3.5L GTDI—INTERMITTENT STUMBLE/MISFIRE ON ACCELERATION FROM HIGHWAY CRUISE IN HUMID OR DAMP CONDITIONS WITH POSSIBLE DTC

TSB 13-3-3

2011-2012 F-150

This article supersedes TSB 12-10-19 to update the Issue Statement and Service Procedure.

Figure 1 - Article 13-3-3

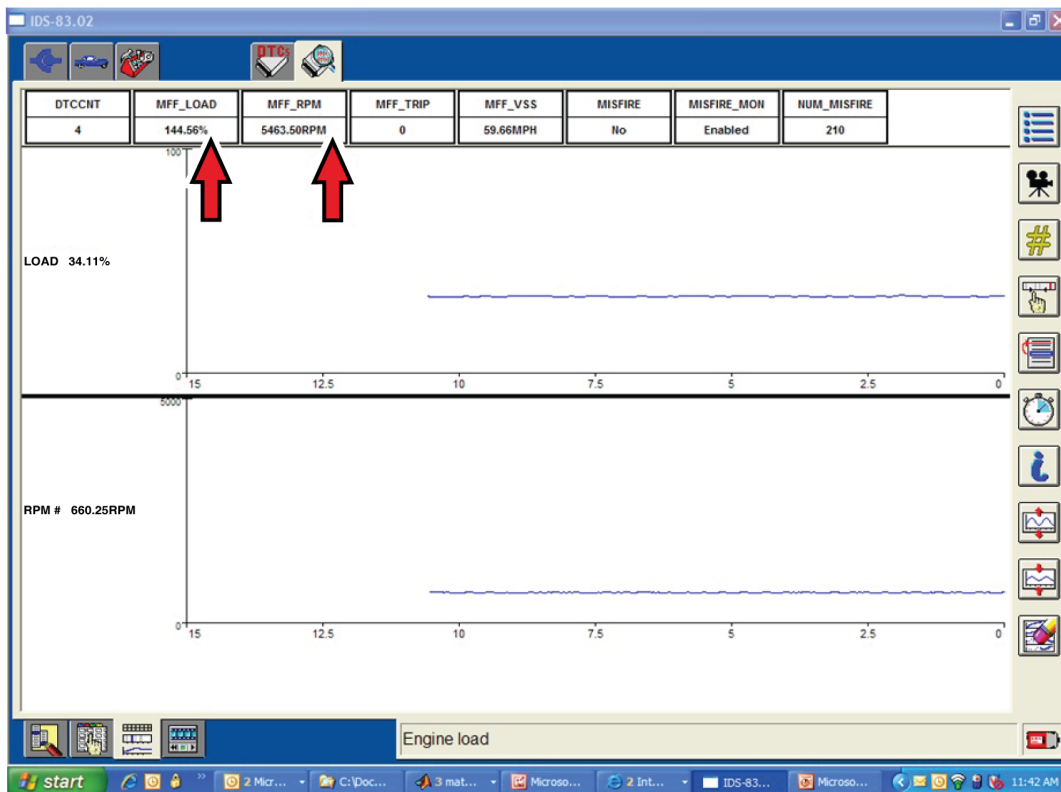
1. Acquire Misfire Freeze Frame Data and DTC's with the IDS. Use the following steps with IDS to obtain Misfire Freeze Frame Data.
 - a. Select Toolbox
 - b. Then Data Logger
 - c. Then Modules
 - d. Then PCM
 - e. Next select the following PIDS: MFF_LOAD and MFF_RPM
2. Check for DTC P0430. Is DTC P0430 present?
 - a. Yes - replace the left bank catalytic converter assembly. Refer to Workshop Manual (WSM), Section 309-00. Proceed to Step 3.
 - b. No - Proceed to Step 3.
3. Is the misfire concern only repeatable in humid or damp conditions?
 - a. Yes - proceed to Step 4
 - b. No - this article does not apply. Refer to Powertrain Control Emission Diagnosis (PC/ED) Manual Section 3: Powertrain Symptom Index to inspect such areas as Ignition, Compression, and Injection.
4. Does the Misfire Freeze Frame Data indicate engine speed above 2500 RPM and load 100% or above? (Figure 1)

- a. Yes - proceed to Step 5.
 - b. No - this article does not apply. Refer to PC/ED Manual Section 3: Powertrain Symptom Index to inspect such areas as Ignition, Compression, and Injection.
5. Is the Charge Air Cooler (CAC) equipped with an air deflector plate? (Figure 2A)
